APPLICATION NO.	FILING DATE	FIRST NAMED INVENTOR	ATTORNEY DOCKET NO.	CONFIRMATION NO.
10/525,004	02/17/2005	Kazufumi Ikeda	2005_0225A	1782
513	7590	10/05/2009	EXAMINER	
WENDEROTH, LIND & PONACK, L.L.P. 1030 15th Street, N.W., Suite 400 East Washington, DC 20005-1503			SUNG, GERALD LUTHER	
		ART UNIT	PAPER NUMBER	
		3741		
		MAIL DATE	DELIVERY MODE	
		10/05/2009	PAPER

<b>Office Action Summary</b>	<b>Application No.</b>	<b>Applicant(s)</b>	
	10/525,004	IKEDA ET AL.	
	<b>Examiner</b>	<b>Art Unit</b>	
	GERALD L. SUNG	3741

## **DETAILED ACTION**

FIG. 7

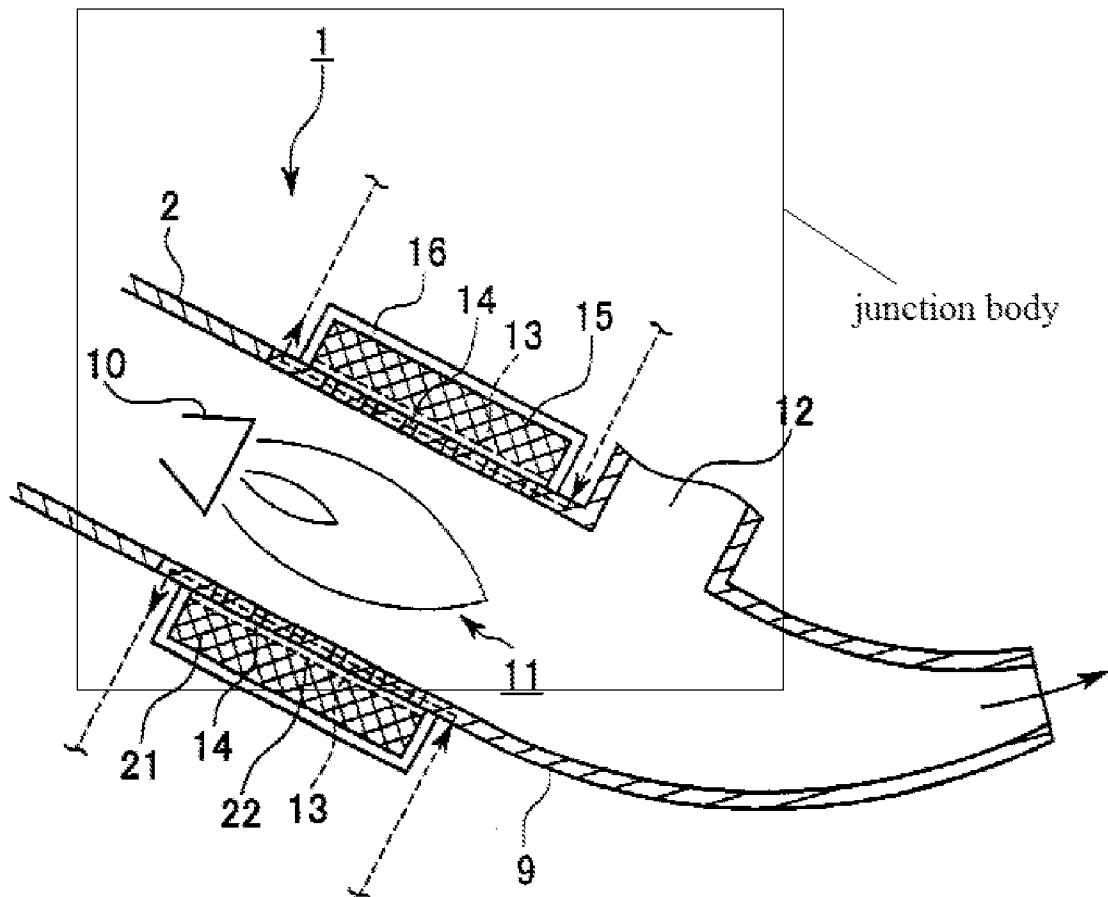
9. Regarding claim 1, Suenaga discloses a gas turbine combustor having a cylinder body comprising a junction body (see figure) having a predetermined length and which has one end thereof open to the cylinder body and a transverse body 14 having vents where the fluid particles cross internal of the junction body and vibrate by resonance. Suenaga does not disclose details of an air container body or a junction body opening to the container body.

11. One of ordinary skill in the art at the time of the invention would have found it obvious to modify the resonator junction body 16 of Suenaga such that a second resonator air container body 64 as taught by Dean is coupled to the junction body 16 of Suenaga in order to provide an increased flexibility in the design of the liner configuration to accommodate a wider range of frequencies.

12. Regarding claim 36, the combination of Suenaga discloses a resonator 16 having a cavity installed around the cylinder body and has sound-absorption holes opening to the cavity formed, wherein, the air container body comprises a first box body 64 which is installed adjacent to the resonator 16, 60 so as to form a first internal space having a predetermined capacity, the junction body 66 comprises the resonator and a first throat which has one end thereof open to the cavity and has the other end thereof open to the

first internal space, the transverse body comprises a side wall 14 of the cylinder body having the sound absorption holes serving as vents.
